ADDENDUM NO. 1

RFID & AUTOMATED MATERIALS HANDLING SYSTEM PROJECT BID

PROJECT 12-30

DATE OF ADDENDUM: April 18, 2012

FIRST FLOOR PLAN SCALE: 1/8"=1'-0" REF. **1**

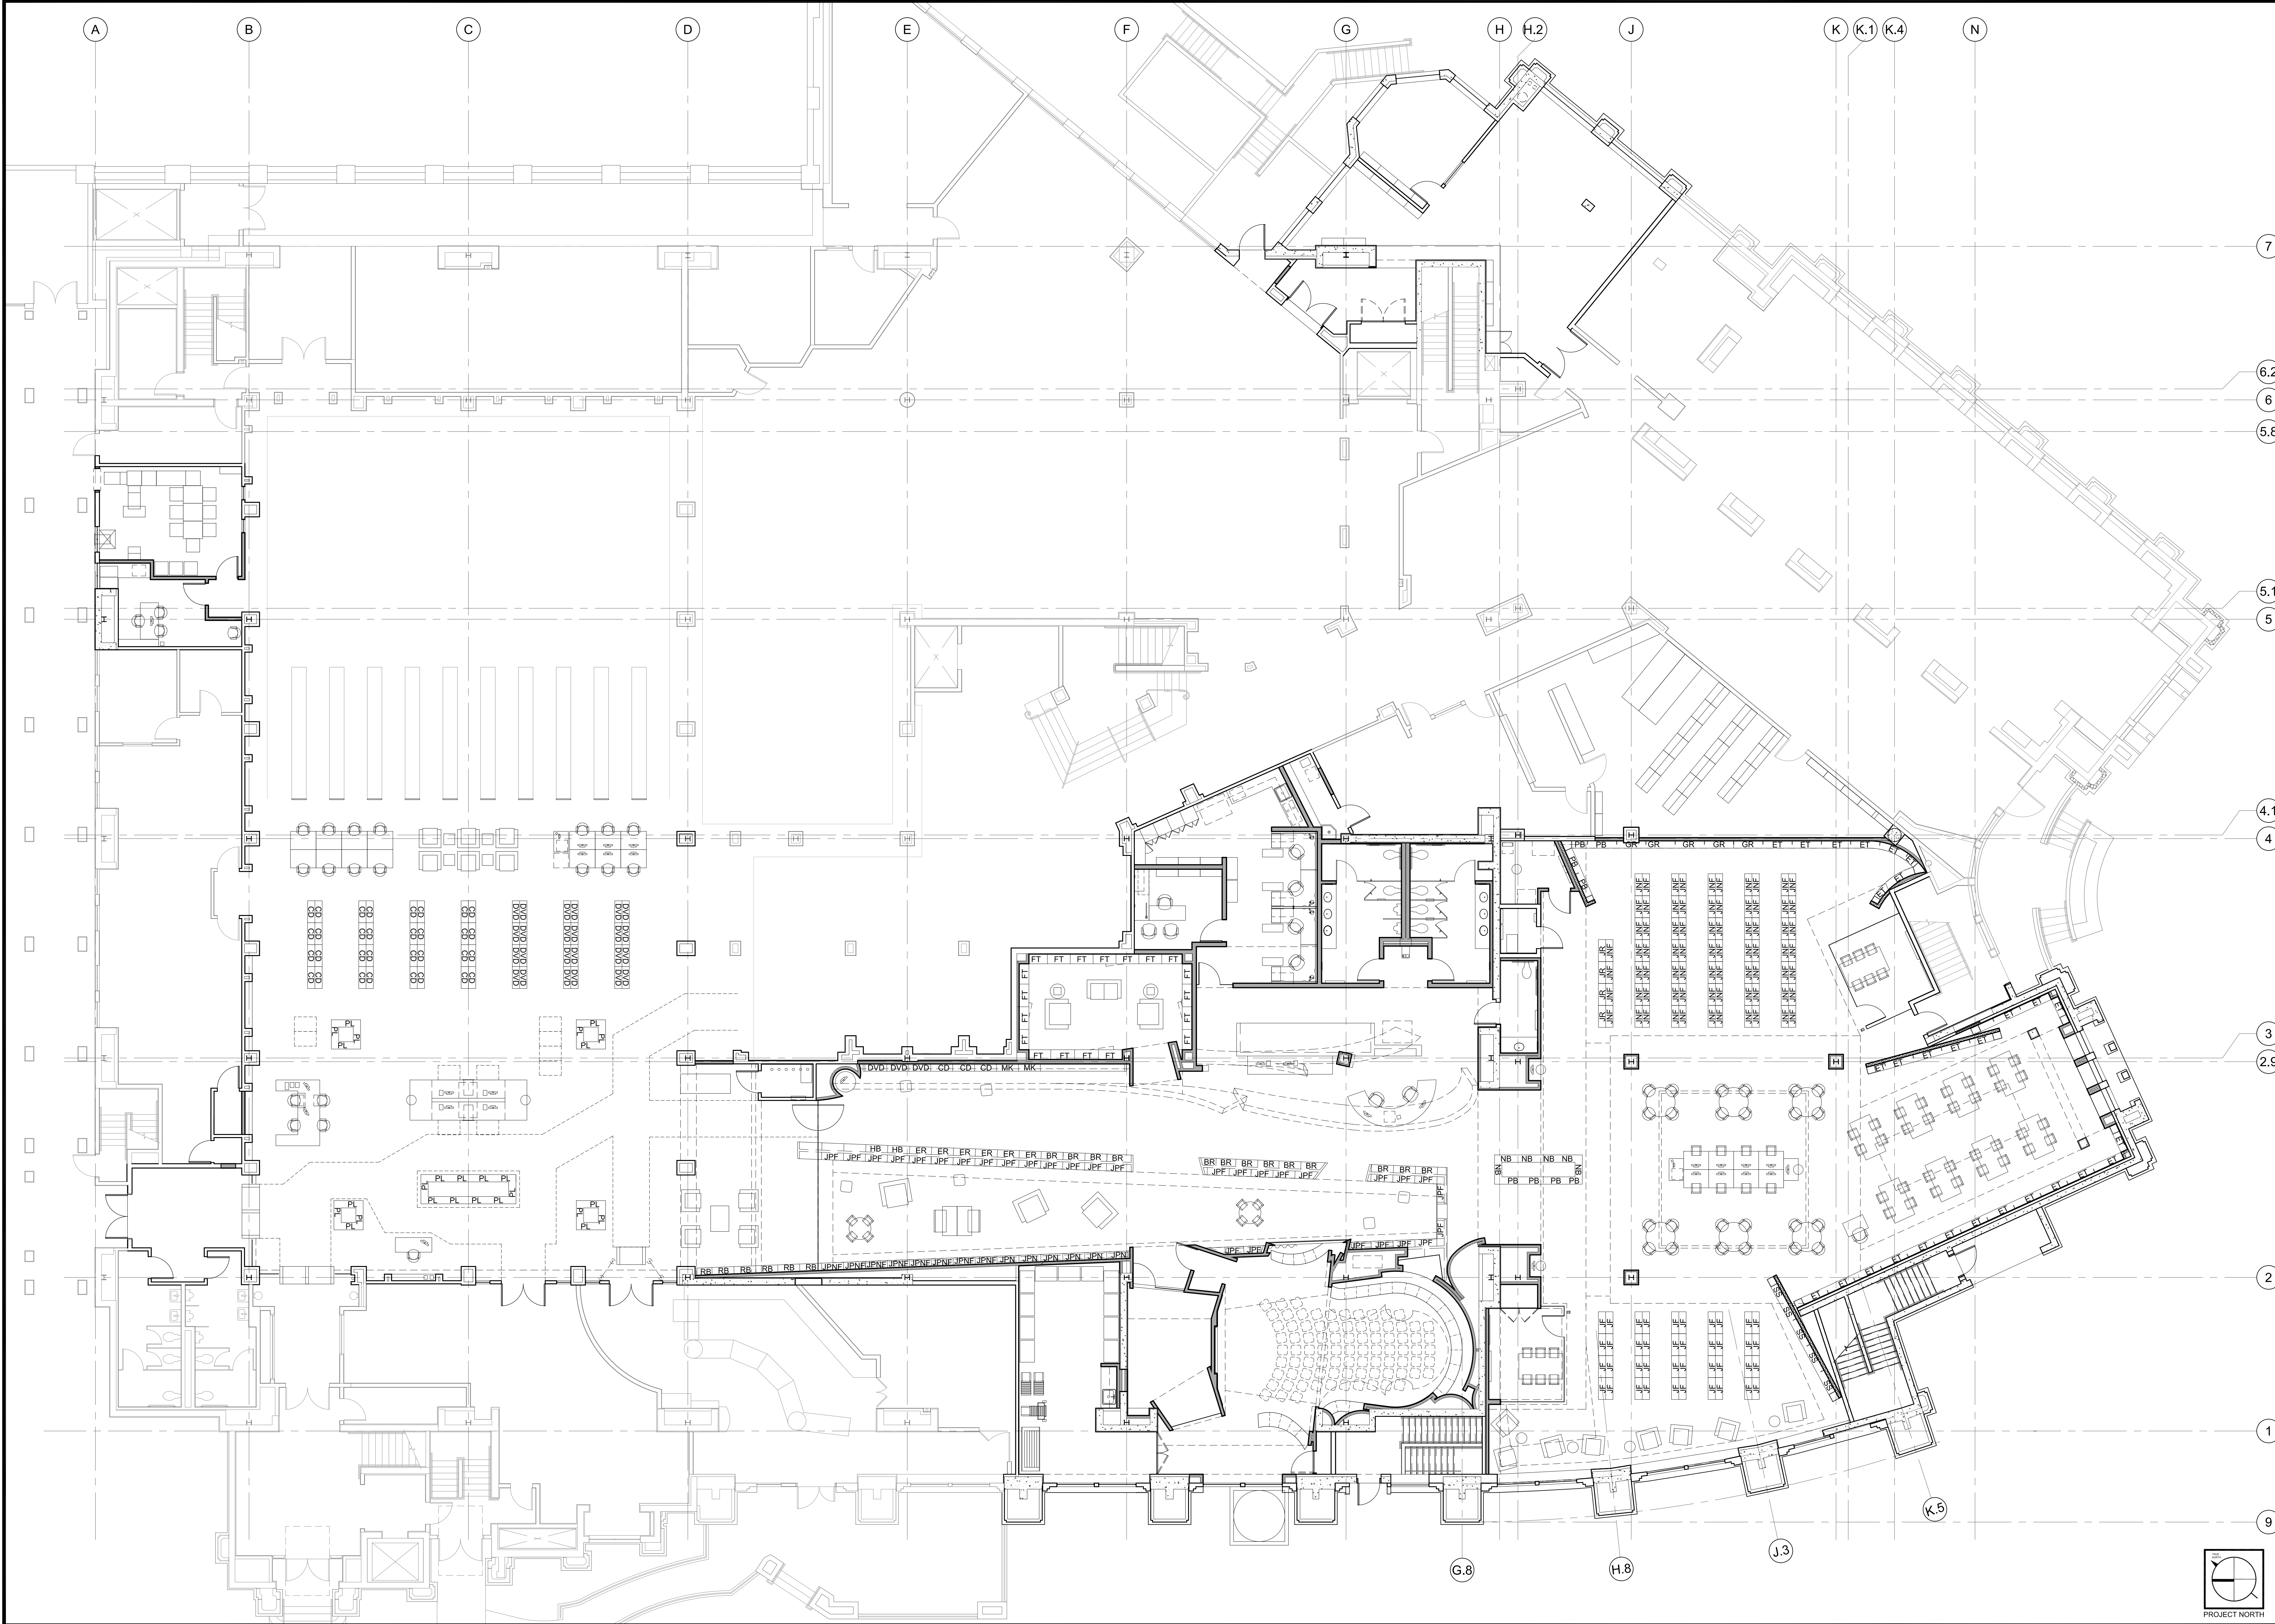
21. What is the desired location of the exterior drop on the diagram?

A: The exterior wall on this diagram is on the left side of the diagram. It is indicated as 12'-10 1/4". Actual location in that wall would be determined the AMHS equipments needs.
